MANCHESTER-BY-THE-SEA

BOARD OF HEALTH

NOTIFICATION TO OWNER

9 PROCTOR STREET, MANCHESTER-BY-THE-SEA

AS-BUILT
SUBSURFACE SEWAGE
DISPOSAL SYSTEM
IN
MANCHESTER, MA
RECORD PLAN

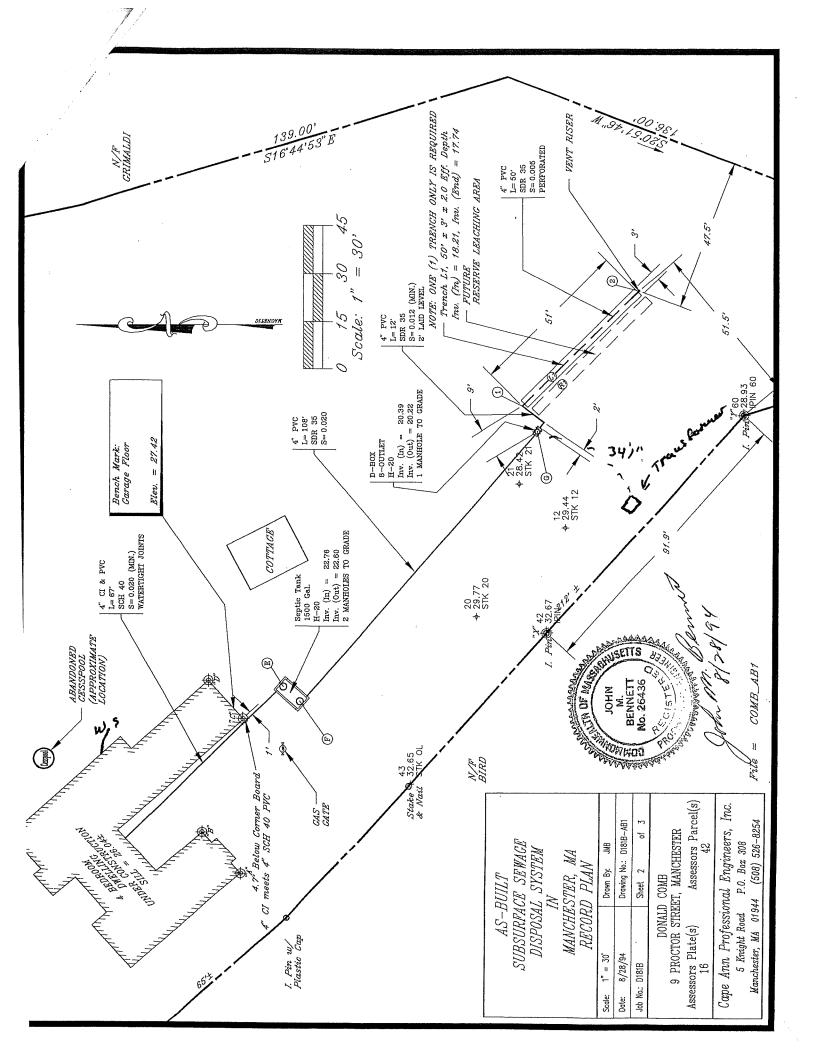
The design flow provided does not match the design plan dated 4/18/94; however,

the system was designed for a 4-bedroom dwelling.
